SM 0164-07 Cape St. Mary's Marina
Concept ■ 07-13200005
Approval

Re: Cape St. Mary's Marina – Major Site Plan

STAFF REVIEW/REFERRAL

TO: The Applicant
FROM: Environmental Review/Dept. of Land Use and Growth Management
SUBJ: TEC Items on Agenda
DATE: April 16, 2007

Existing Condition & Environmental Features Cape St. Mary's Marina

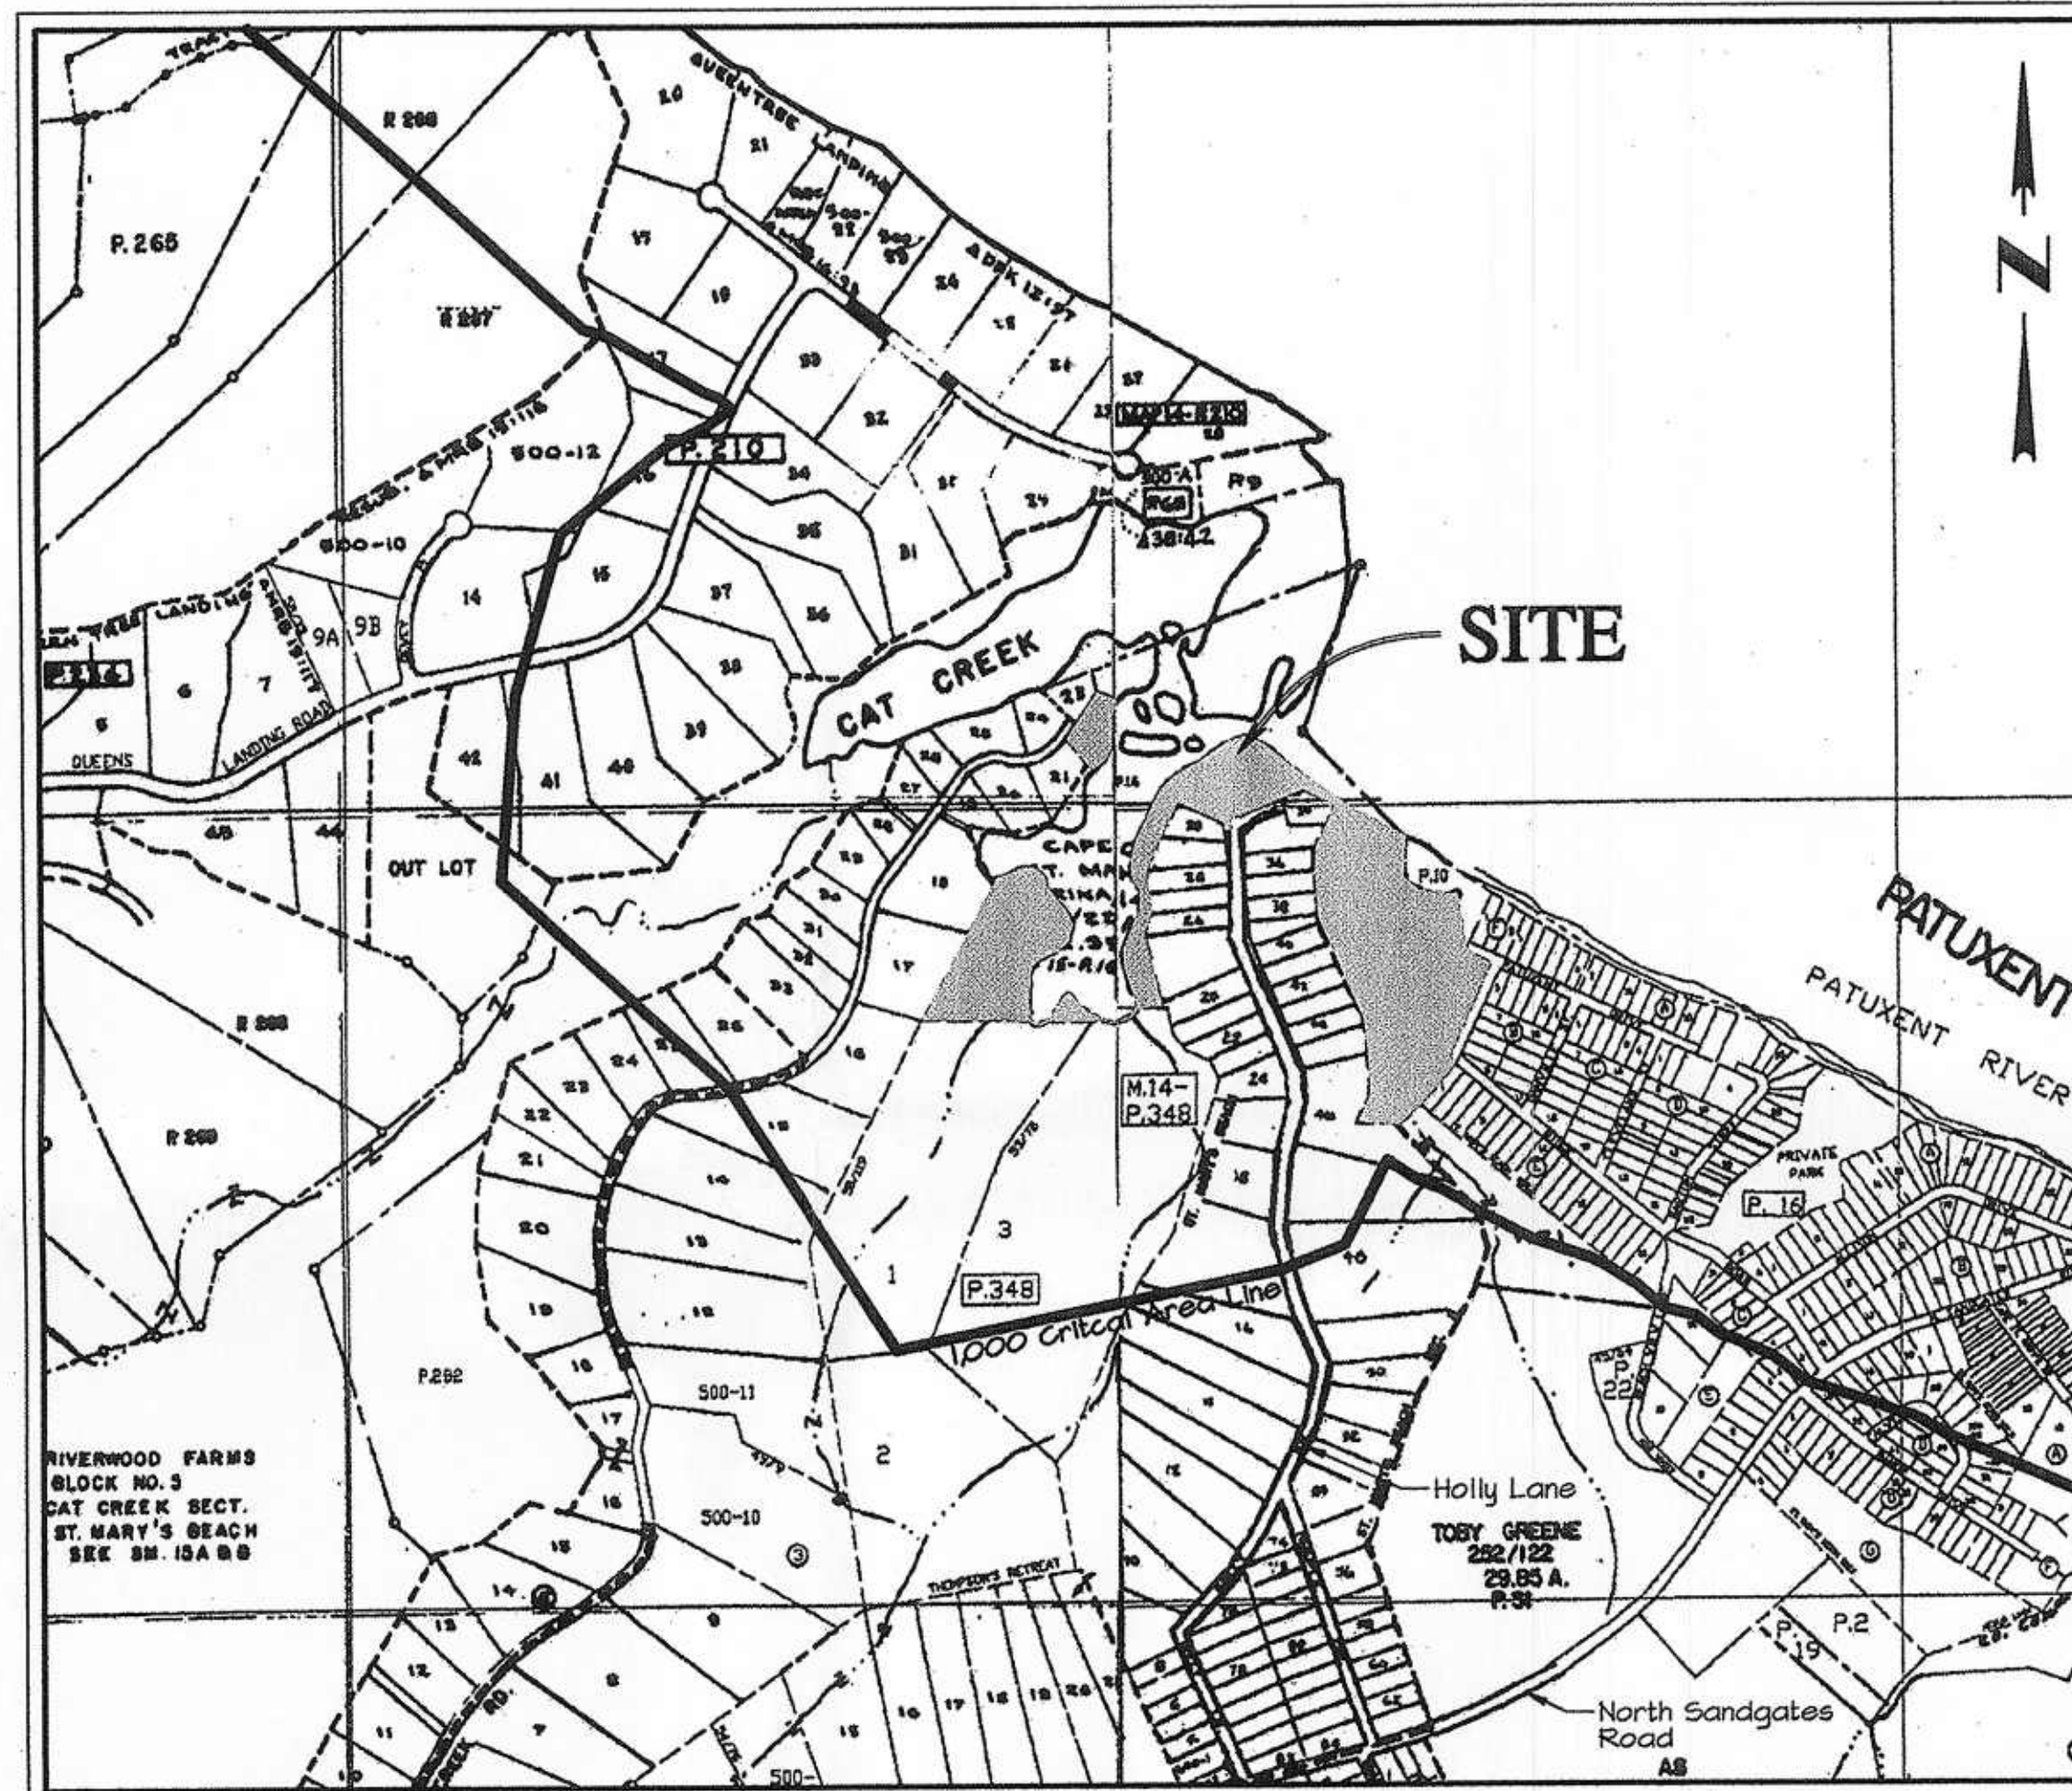
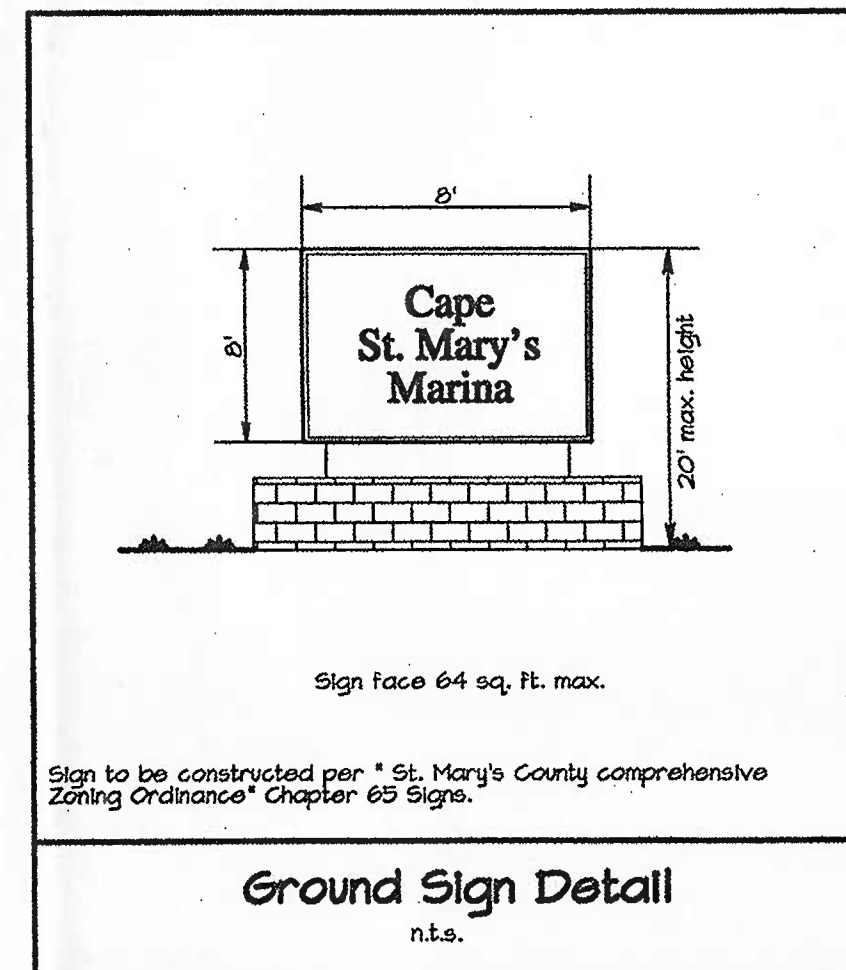
1. It appears the 100-foot Buffer has not been properly expanded in areas of steep slopes and should be revised.
2. While the existing marina is designated as a water-dependent facility, Section 41.8 of the Comprehensive Zoning Ordinance (CZO) states that only those specific operations and structures that must occupy the Buffer in order to serve their function may be located in the Buffer. The new marina office/restaurant is restricted from this list and therefore may not be relocated in the Buffer as proposed.
3. Similarly, the proposed bath house should be located entirely outside of the expanded 100-foot Buffer.
4. My review of GIS data indicates a stream may be located on the property running through the nontidal wetland. Per Section 71.8.3 of the CZO tributary streams require a 100-foot Buffer. Additionally, the site plan should show a 25-foot buffer around the nontidal wetland.

- b) The expanded Critical Area Buffer is not properly delineated on the Existing Conditions plan. Due to highly erodible soils (EwE2), steep slopes, hydric soils (Tm), and the areas of tidal and nontidal wetlands, the entire site is encumbered by the expanded CA Buffer. Properly show the expanded CA Buffer on the plans, change CA note 2 to say "expanded CA Buffer" and update the impervious surface figures in the applicable CA notes accordingly.

Concept Plan

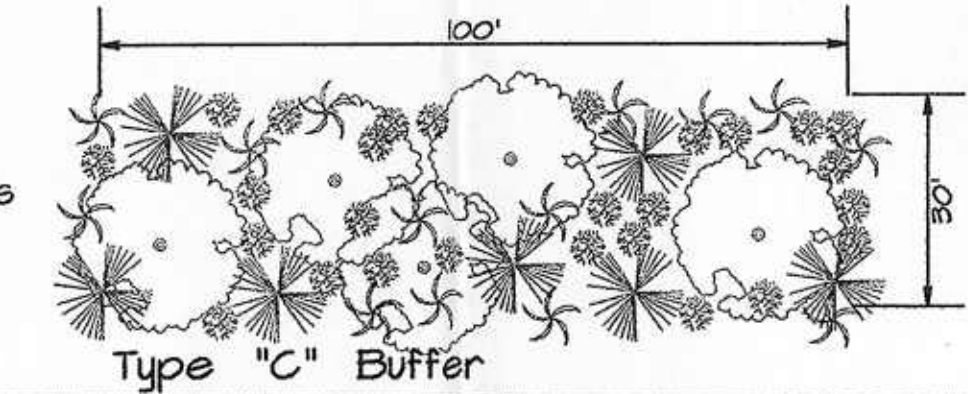
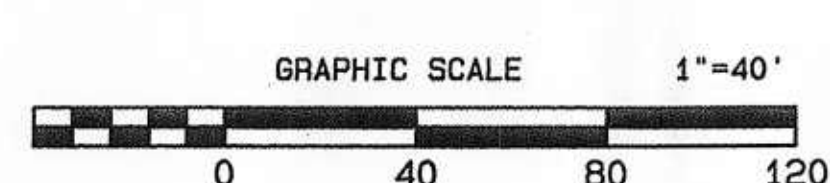
4. Per LUGM TEC comments of 4/12/08, please add bearings & distances to all boundary lines, including the shoreline.
5. Per Environmental Review comments of 4/16/08, please revise the width of the boardwalk along the bulkhead to be 3 feet because any greater width may require a variance.

8. Since a restaurant/office structure is not allowed in the Critical Area Buffer under the current Comprehensive Zoning Ordinance per Section 41.8.2.(2), the structure is nonconforming to the regulations. Per Section 52.3.2 no nonconforming structure shall be moved unless required by law, or unless the movement (relocation) will result in the elimination of the nonconformity. There are provisions for expanding or enlarging a nonconforming use/structure per Section 52.3.3, however, please consult with the Zoning Administrator, Yvonne Chaillet, of this office, and provide evidence that this structure is eligible for relocation, expansion, or enlargement.

- a) Add the CA Boundary to the vicinity map.
- b) It appears that the parking space immediately adjacent to the travel lift slip is impractical due both to the activities associated with launching and pulling boats and to the location of the proposed relocated gas pump. Relocate that space. See also comment 2)a)i). Provision of planting bed will

- a) Regarding §41.5.3.i.(3) Impervious surface trading:
 - i) Per paragraph (a), for a site that exceeds the impervious surface limit, when one trades IS the areas where IS is removed should be planted in natural forest vegetation. Staff recognizes the purpose of moving the restaurant office structure is to revise the parking and ramp access to improve site circulation and parking. Therefore staff would recommend that an area equivalent to the footprint of the restaurant be established elsewhere in the Buffer as a means to capture and infiltrate runoff before it enters the tidal waters.

- (1) Provide a 3 foot boardwalk at the bulkhead to accommodate access to the shoreline or transient boats for fuel purchases, and for restaurant and office customers.
- (2) Provide a minimum 15 foot wide x 200 foot long planting bed planted to the end of the bulkhead and a minimum 5 foot wide x 160 foot long planting bed along the gravel area behind the restaurant/office (approximately 3700 s.f.)
- (3) Provide controlled access to the beach and board walk via several board or gravel walks cross the planting beds to eliminate damage to plantings from foot traffic.
- (4) All planting beds in the CA Buffer to be planted with native salt tolerant trees, shrubs and perennials

I met with the owners consultants on Friday and told them they must reduce the building size to the same footprint area as the current restaurant/office because an expansion triggers not only a variance but nonconforming use issues as well. They agreed to do this. It is my understanding that the boatel is to be removed and an replacement shop constructed but I note that Christine who reviewed the plan questioned whether this was true and also questioned the size of the replacement shop building. If the shop is a partial replacement of the boatel the expanded footprint would need a variance, if a replacement the shop would need to have the same footprint as the boatel. I am bringing this to the owner's consultants' attention.

The walkway adjacent to the new planting beds is at the edge of the bulkhead because it is used for tying up boats launched from the public ramp and for fueling. Non slip holders using the public ramp, transients, and restaurant patrons will be tying up and accessing boats from the walkway, hauling supplies and materials to an from boats using dock carts and I am told that there is need for the walk for wheel chair access for one of the marina patrons who currently has to be carried to get to his boat. Because of the use of the walk I believe a 6 foot wide walk can be justified as water dependent and should be approved to be located in the Buffer.
